Memo

From: Plan Review Committee of the Verona Environmental Commission

Re: **Case # 2026-04**
420 Bloomfield Avenue [Block 701, Lot 3]
Verona, New Jersey

Zone: Town Center Zone (Redevelopment Area)

Drawing Name:
EXISTING CONDITIONS PLAN

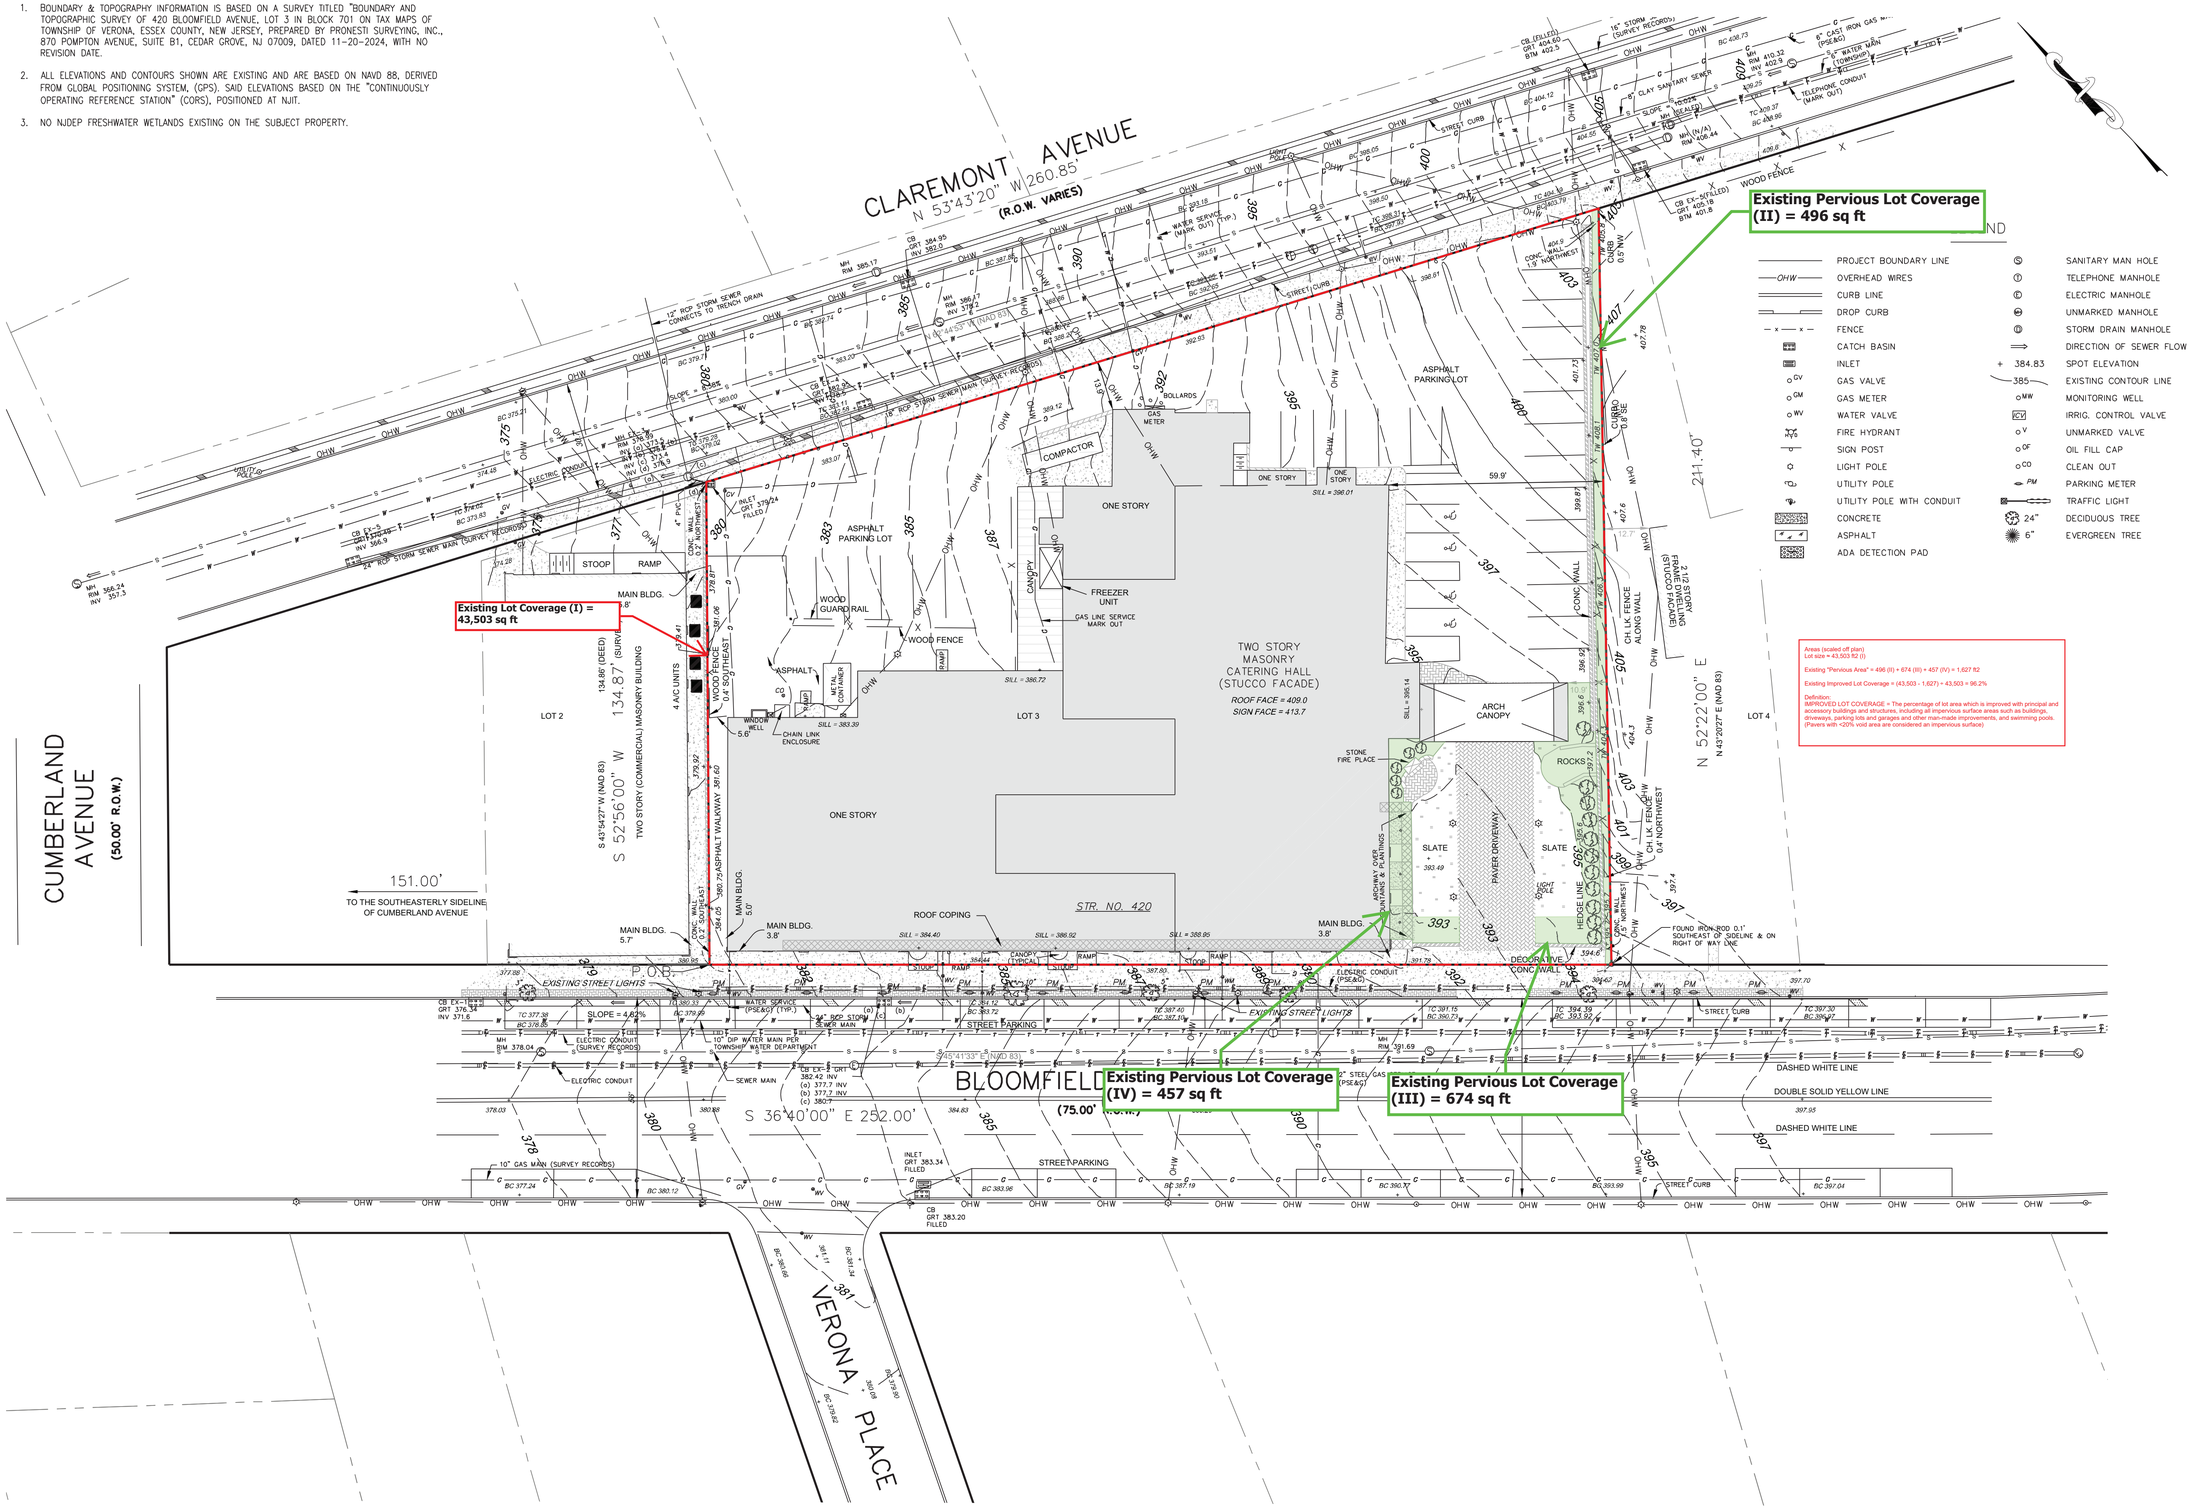
2) Scaling off Drawing No. C-100, we calculated an Existing and Proposed Total Improved Lot Coverage of 96.2% and 90.5% (please see attached annotated pdf), respectively. We understand that the maximum Improved Lot Coverage allowable in the Redevelopment Area for 420 Bloomfield Avenue is 90%.

Areas (scaled off plan)
Lot size = 43,503.52 (I)

Existing "Pervious Area" = 496 (II) + 674 (III) + 457 (IV) = 1,627 ft2

Existing Improved Lot Coverage = (43,503 - 1,627) ÷ 43,503 = 96.2%

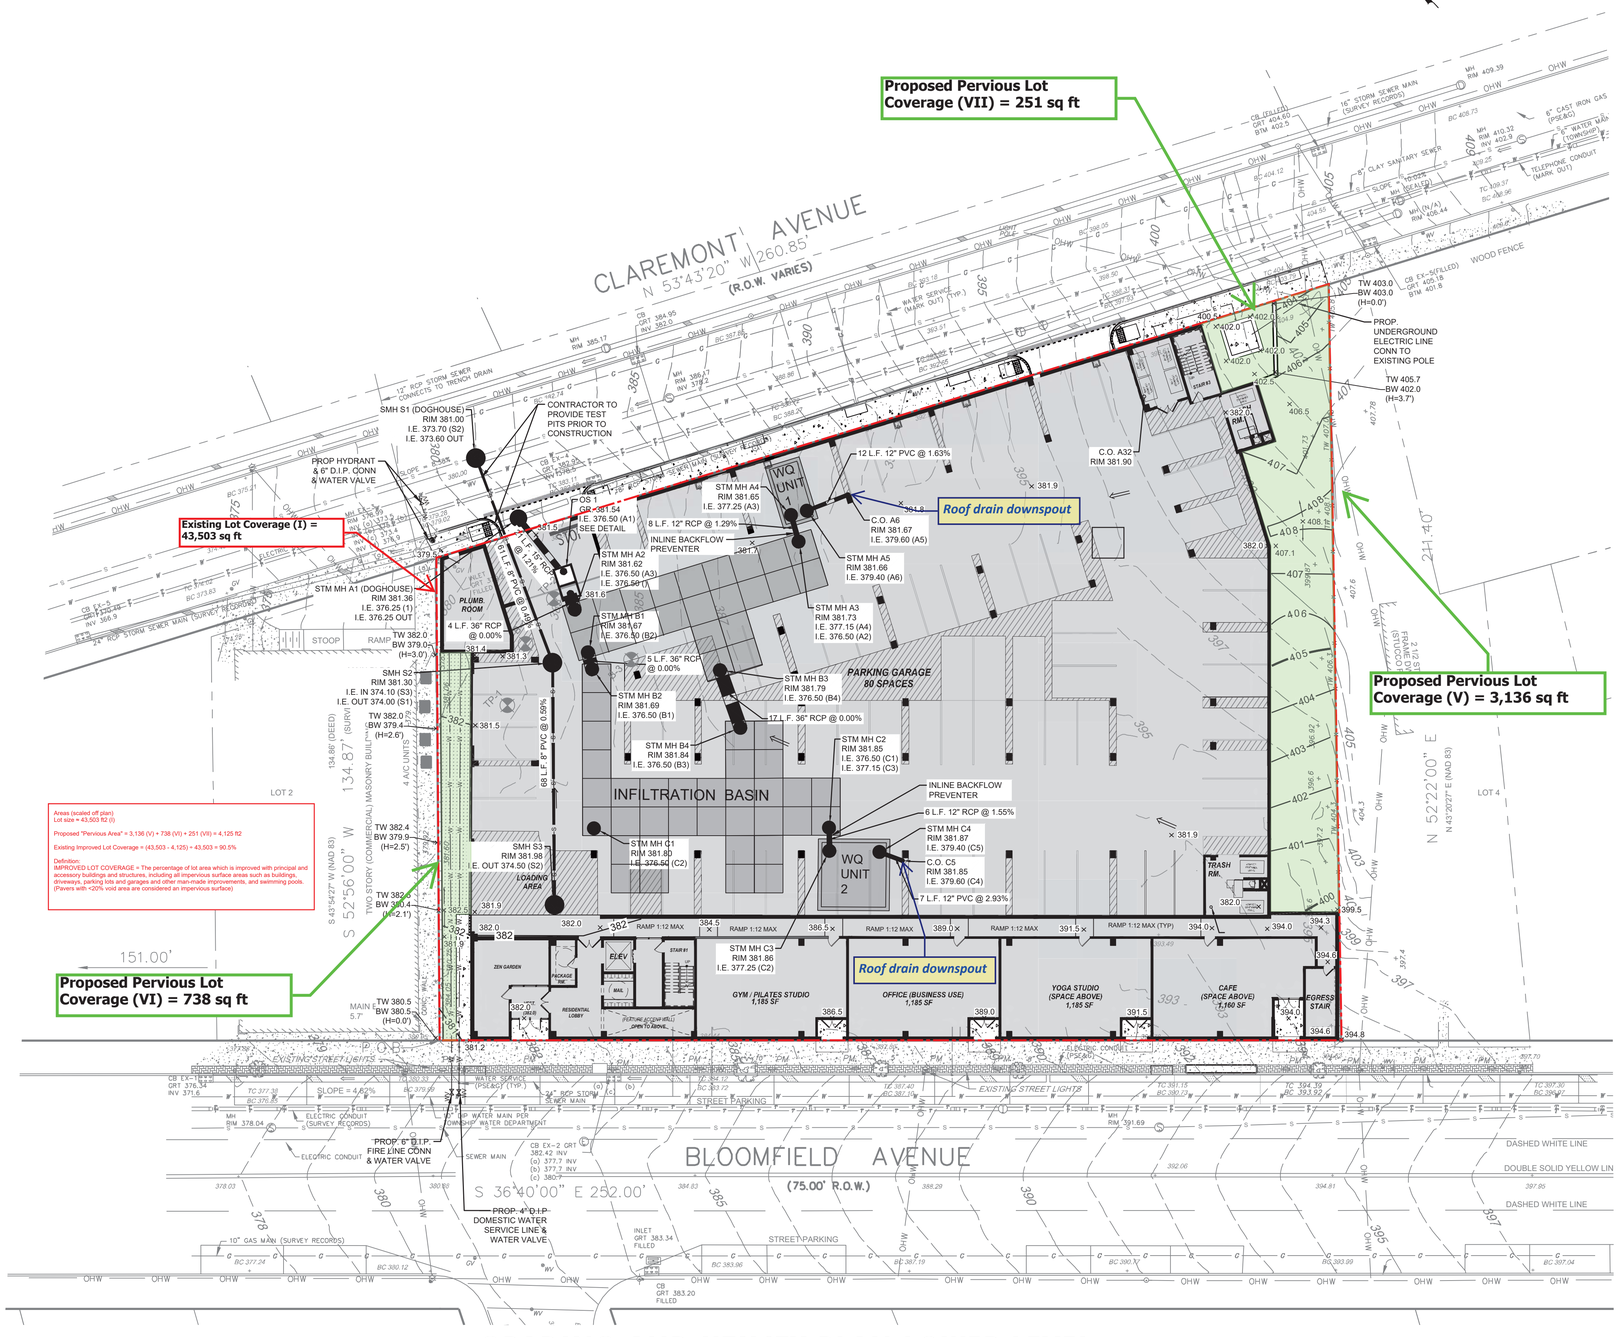
Proposed Pervious Lot Coverage (VII) = 251 sq ft
Existing Lot Coverage (I) = 43,503 sq ft
Proposed Pervious Lot Coverage (V) = 3,136 sq ft
Proposed Pervious Lot Coverage (VI) = 738 sq ft
CLAREMONT AVENUE
N 53°43'20" W 260.85'
(R.O.W. VARIES)
BLOOMFIELD AVENUE
